IloT Product End-of-Life Notice

End of Life, Last Time Buy and Replacement Announcement

For immediately release, Advantech is announcing the End of Life (EOL) of **FPM-5151G, FPM-5171G, and FPM-5191G**. The relative replacing models are as below list. Customers who had purchased this Part Number either to purchase any additional rules or migrate to the new replacement models if possible before the EOL's shipment date.

1) New LCD panels

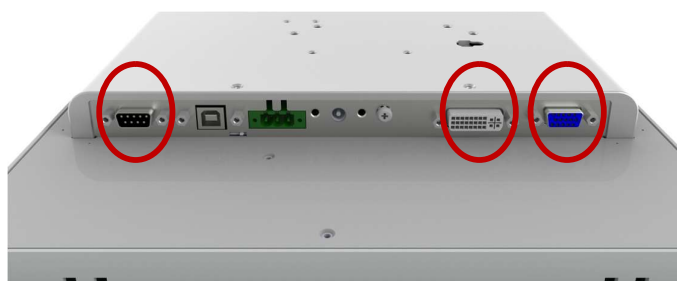
Due to the EOL of the current 19" LCD panels, and the long period of usage of the current 17" LCD panel approaching EOL, the new LCD panels are applied in the successor models.

2) More video input options

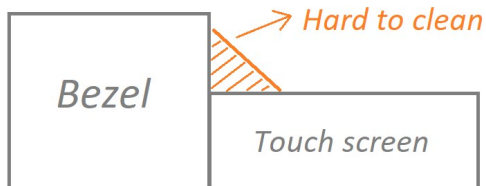
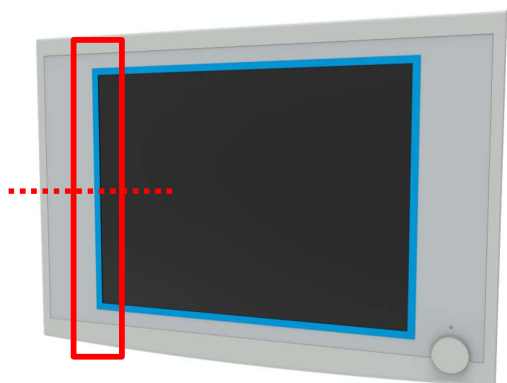
Besides traditional analog video input port (VGA), digital video input ports (HDMI/DP) are added to the successor models to connect to more and more applications.

RS-232/DVI-D/VGA

RS-232/USB 2.0/HDMI/DP/VGA
